**APPLICATION FOR ARCHITECTURAL & DESIGN REVIEW APPLICATION  
AT**

**5306 IRISH LANE  
MADISON, WI 53711**

**ATC SITE #410942**

RE: Site Name: ATC410942  
5306 Irish Lane  
Madison, WI 53711

## LEVEL 2 ACOUSTIC ENCLOSURE SD80 4.5L IVECO

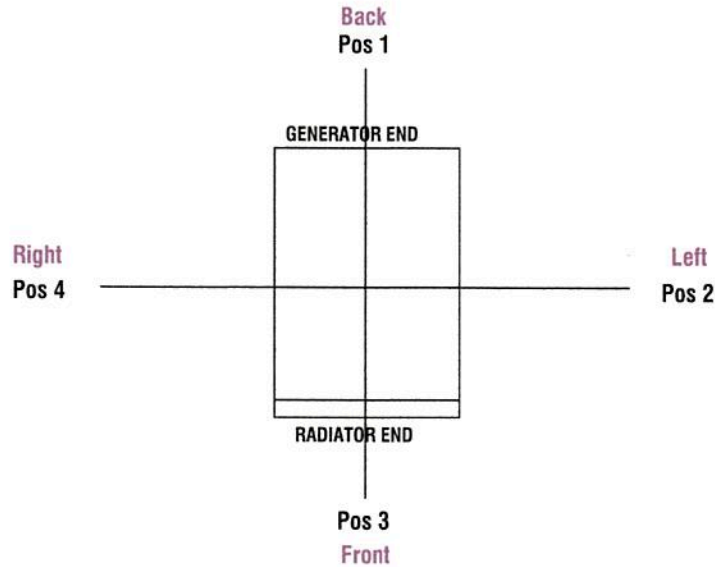
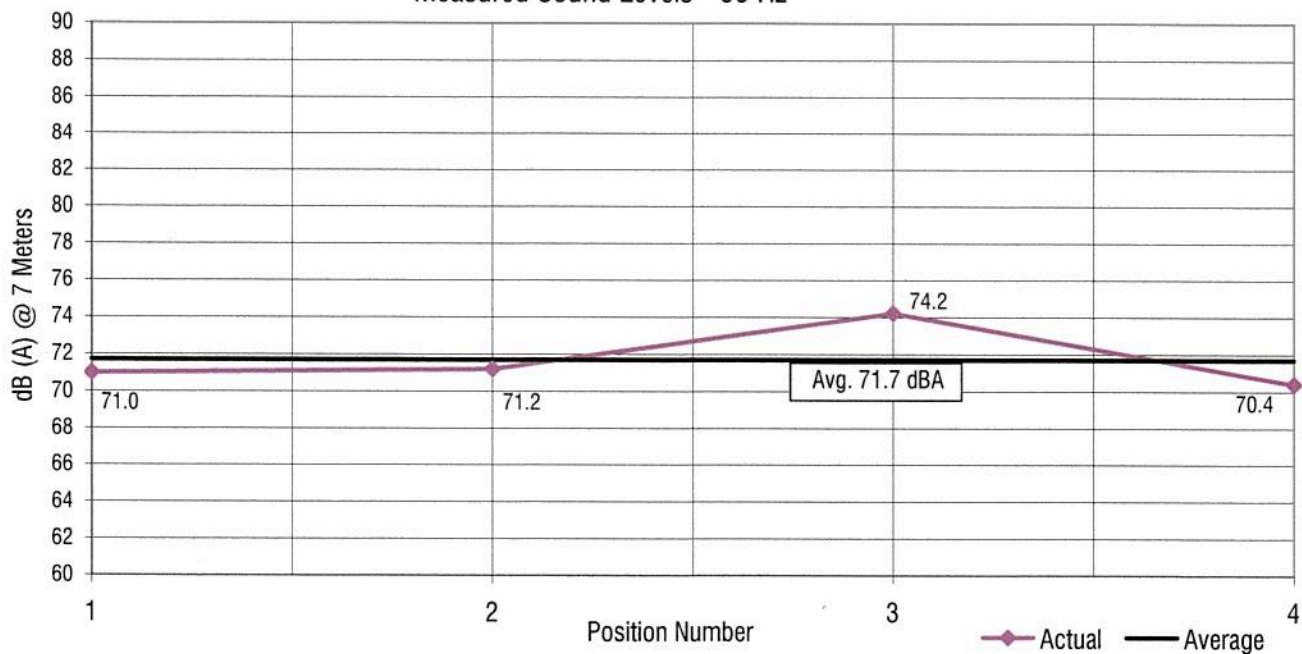
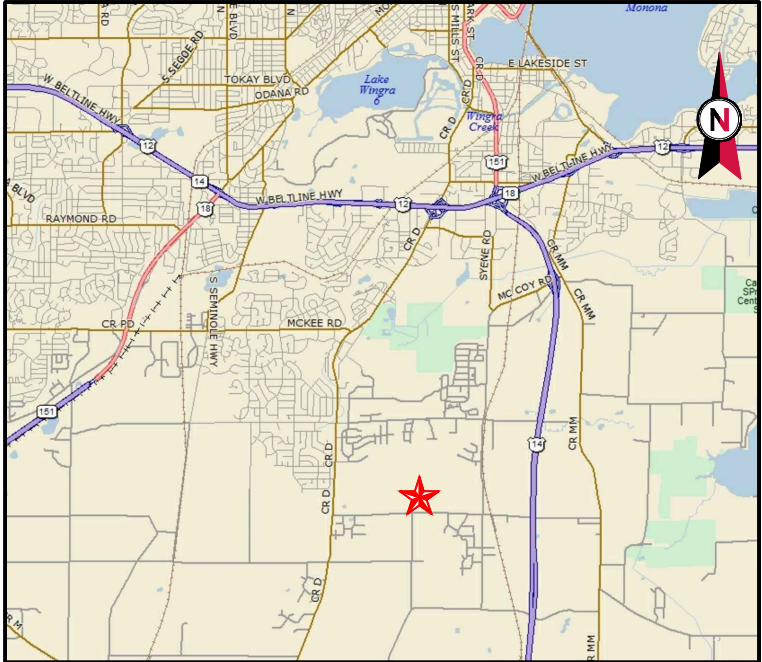
4. What is the sound (dBA) of the proposed generator at 50' from each direction? **Per the attached cut sheet we sent the maximum dba is approximately 71.2 dba at a distance of 23' from the generator. At 50' the level would be at or below the 65 dba required in the City's zoning ordinance.**
